TO: Mercedes-Benz Dealer Principals, General Managers, Sales Managers, Service Managers, Parts Managers	FROM: Gregory Gunther, Department Manager, Vehicle Compliance and Analysis, Engineering Services
RE: Emission Modification Notification – [[2020050019]] MY 09 ML320 BlueTec 4MATIC Update – Emission Modification Category (EMC) #5	DATE: May 27, 2022

SUBJECT: **Model ML-Class diesel vehicles (W164 platform)**
Model Year 2009
Modification to the emission control system

Figure 4

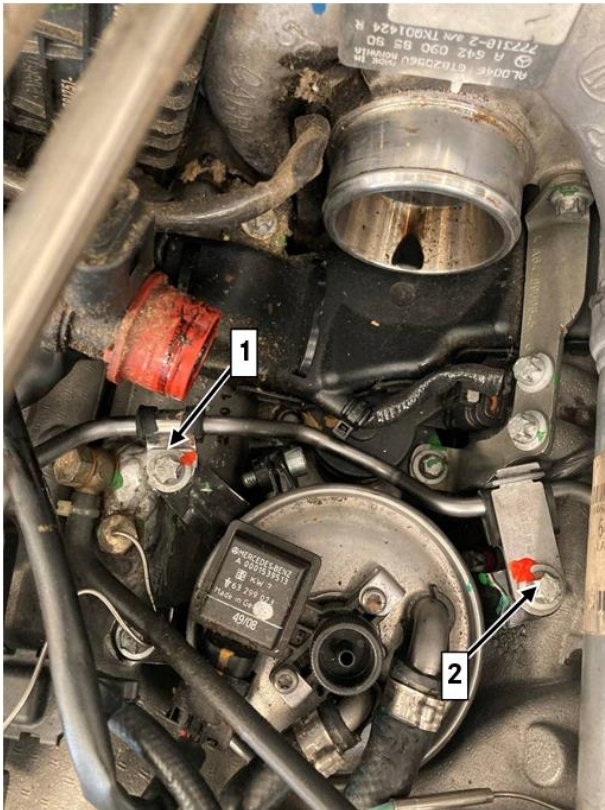
- i** The line from the left fuel distributor to the right fuel distributor is replaced by a new version (A 642 070 09 00) (**Figure 4**). A new clamp (1, **Figure 4**, (N 000000 006288)) with new bolt (2, **Figure 4**, (N 000000 001116 M6x19mm)). The old bracket on position (2, **Figure 4**) is reused and with a new bolt (N 000000 001114 M6x15mm) fastened. The old bracket must be reinstated as shown. Chafe-free routing must be ensured.

Figure 7

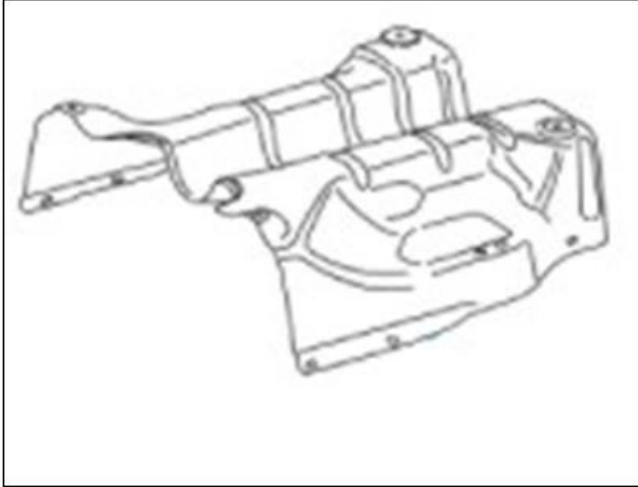
5. Replace the exhaust heat shield (A 164 682 47 71) (**Figure 7**).
